Ontario
Energy
Board | Commission
de l'énergie
de l'Ontario

**Re: Ontario Power Generation Inc. and DNNP LP (the Applicants)
2027-2031 Payment Amounts
Ontario Energy Board (OEB) File Number: EB-2025-0297**

OEB Staff Interrogatories
2027-2031 Payment Amounts Application
Ontario Power Generation (OPG) and DNNP LP
EB-2025-0297
March 11, 2026

Chart 1 – SBG Spill Booked to SBGVA – MWh (May – Sept)

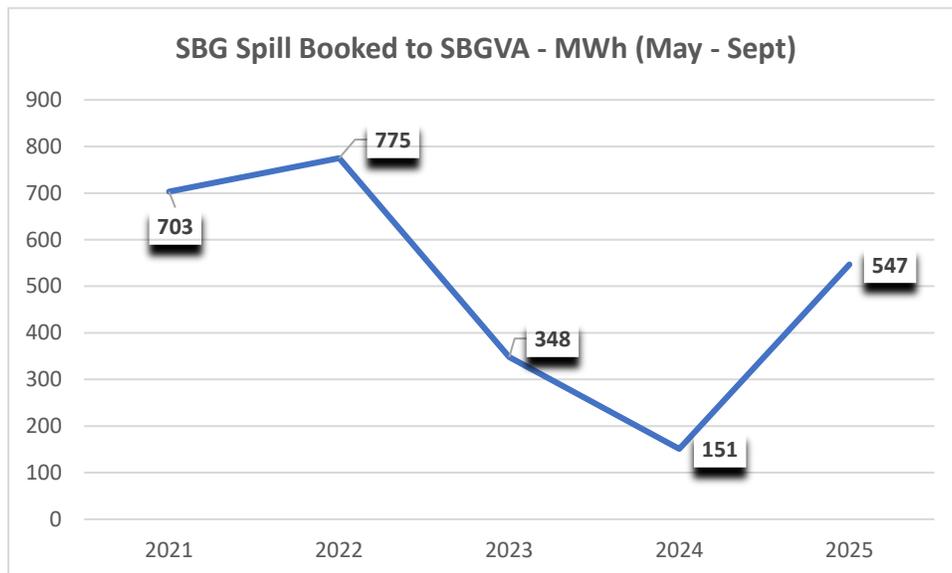
At Reference 2, OPG provided a table that sets out “SBG Spill Booked to SBGVA (MWh)” on a monthly basis, for 2021 – 2025.

OEB staff focused on comparing the same subset of months that Surplus Baseload Generation (SBG) spill data was provided by OPG for the Renewed Market (May to September) across all the years. That is reflected in the chart below which shows the amount of SBG spill booked to the Surplus Baseload Generation Variance Account (SBGVA) declining substantially in the years before Market Rate Program (MRP) was implemented – from 2021 & 2022 (both years over 700 MWh) to 2024 (151 MWh). In the months following MRP Go-Live, it then increased considerably (547 MWh).

Chart 1 – HIM Revenue

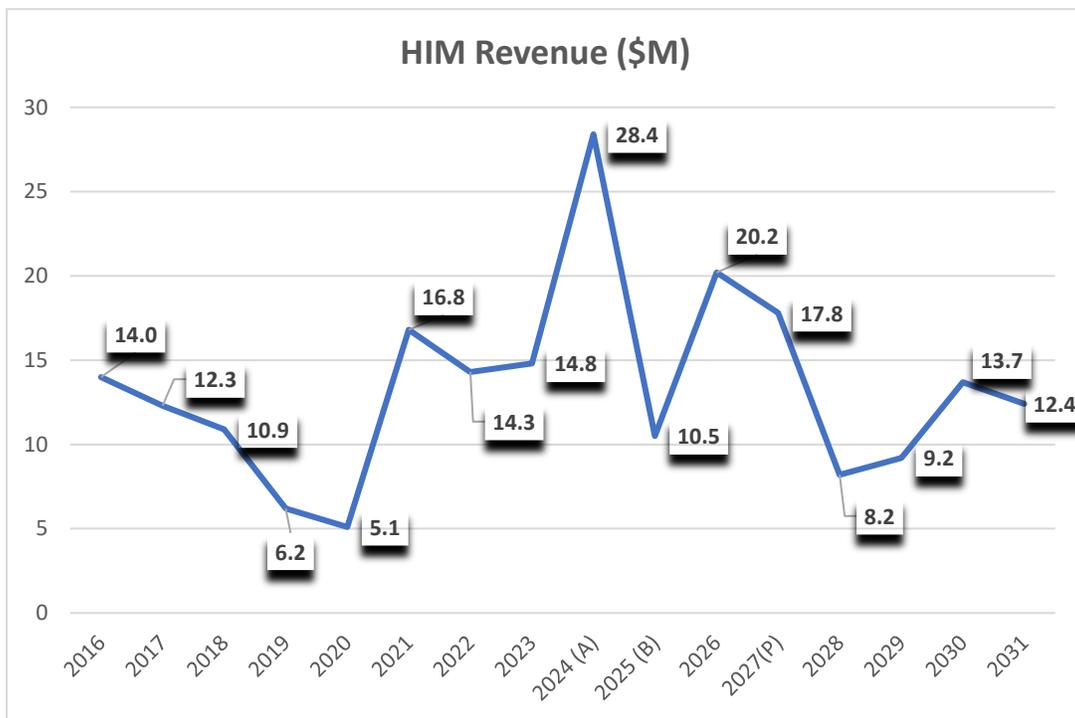
OEB staff created the chart below based on the Hydroelectric Incentive Mechanism (HIM) revenues provided by OPG in Table 1 of Reference 1 to better understand the trends.
